PREPARED FOR THE PLAN COMMISSION

Project Address: 216 South Pinckney Street (District 4- Ald. Verveer)
Application Type: Planned Development (PD) Rezoning and Conditional Use
Legistar File ID # [59306](#) and [58805](#)
Prepared By: Kevin Firchow, AICP, Principal Planner - Planning Division
Report includes comments from other City agencies, as noted

Requested Actions: The applicant requests approval to rezone the subject property (“Block 88” – Judge Doyle Development) from Planned Development-General Development Plan-Specific Implementation Plan (PD-GDP-SIP) to Amended PD-GDP-SIP. The request also includes a request for a conditional use alteration to amend the projections into the Capitol View Preservation Height Limit.

Figure 1. Previously Approved Capitol View Height Projections – 2017

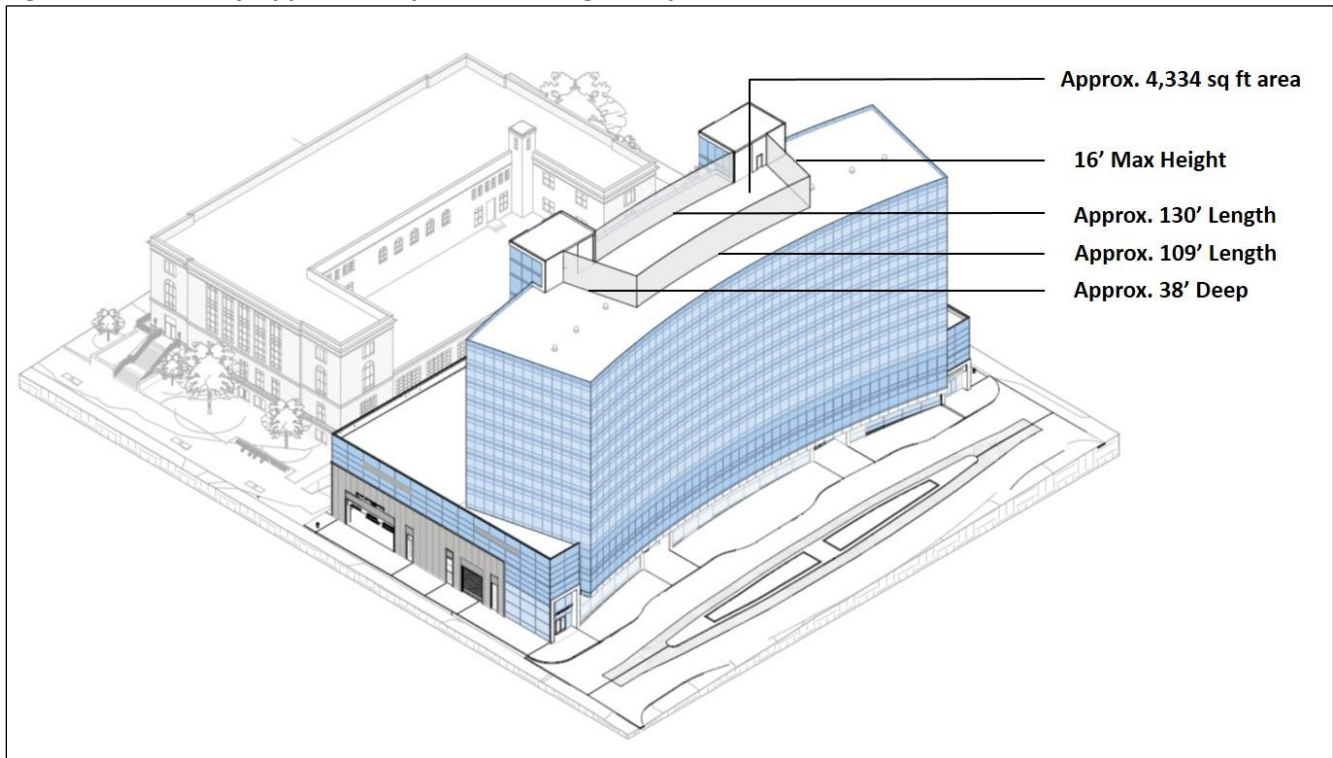
A conditional use for a larger projection was approved by the Plan Commission in April 2017 allowing for up to a 16-foot projection into the Capitol View Preservation limits. That approval was conditioned upon the height of the screening being the minimum height necessary to screen equipment. In addition to the elevator penthouses, the mechanical screening area was approved up to an area of approximately 4,334 square feet. The following graphic and dimensional information are from the plans presented to UDC dated June 13, 2017. As a reference, the top of the main building parapet wall was approved right at the Capitol View Preservation Height Limit.

In comparison, the ***current proposal*** reduces the height and mass of the approved projection depicted above. As currently proposed, the mechanical screen height has a height of just under 10 feet above the Capitol View Preservation Height limit. It has an area of approximately 149 by 24 feet, covering a calculated area of 3,576 square feet.

Considering the previous approval for a larger encroachment, the reduction in height and mass, as well as a favorable recommendation from the Urban Design Commission, staff believes the conditional use standards can be found met.
